Lime Down

Solar Park

The Applicant's Response to Written Representations

Document Reference: EXAM/9.22

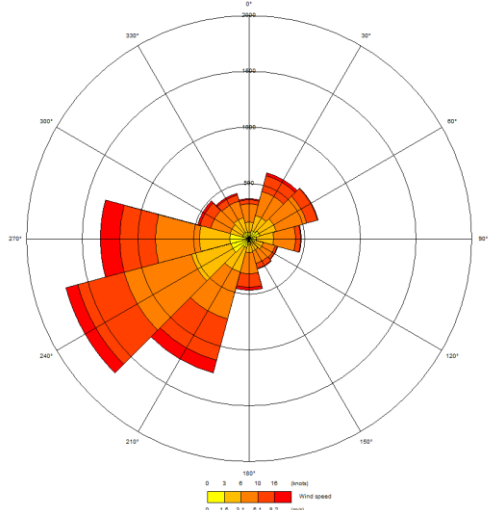
DF-033	Hydrology, Flood Risk and Drainage	Flood risk	Respondent included two images captioned: Left: Proposed site of the Solar Panels flooded adjoining to the South of [redacted] not flooded.	The photographs are acknowledged. They appear to show existing flooding of land within or adjacent to the known floodplain. They do not, on

Reference	Theme	Issue	Comments/Issue Raised	Applicant's Response
				their own, demonstrate that the Scheme would increase flood risk. Photographs do not provide surveyed flood levels, measured depths, flow velocities or hazard ratings. Existing floodplain behaviour has been considered in the relevant site-specific FRA, including ES Volume 3, Appendix 11-6: Flood Risk Assessment and Drainage Strategy Lime Down D [REP1-047] where relevant to Gauze Brook. The relevant assessment is whether the Scheme would materially increase flood risk, and the submitted assessment concludes that it would not.
DF-034	Soils and Agriculture Hydrology, Flood Risk and Drainage	Flood Risk	The Applicant has provided no real assurance that disturbance of the soil in the proposed development fields will not cause increased flooding on my side of the boundary. At consultation I saw little evidence that the project team understood that the fields they intend to develop sit on a flood plain, or that the area can carry	The Applicant recognises that land adjacent to Gauze Brook can experience flooding during heavy rainfall. That existing floodplain behaviour is reflected in ES Volume 3, Appendix 11-6: Flood Risk Assessment and Drainage Strategy Lime Down D [REP1-047] .

Reference	Theme	Issue	Comments/Issue Raised	Applicant's Response
			approximately two foot of water spanning around 100 metres from the Gauze Brook in heavy rain. Video evidence is available. There are numerous examples of Malmesbury flooding with 2024 described as the worst event for 25 years.	The Scheme's interaction with that floodplain has been assessed. The BESS and substations are located in Flood Zone 1. Solar PV panels within areas of flood risk are flood-compatible and raised above ground. The Scheme would not materially reduce floodplain storage or displace floodwater onto neighbouring land. In relation to runoff from panelled areas, the Applicant's position is supported by national policy, drainage guidance and published research. NPS EN-3 paragraph 2.10.84 recognises that panels drain to ground. Research by Cook and McCuen (2013), Yavari et al. (2022), Elamri et al. (2018), Gullotta et al. (2023), Wang and Gao (2023) and Baiamonte et al. (2023) identifies ground cover, compaction, surface roughness and flow connectivity as the relevant controls on runoff response. These are secured through the Outline CEMP [REP1-096], Outline OEMP [REP1-098] and Outline SRMP [APP-280].
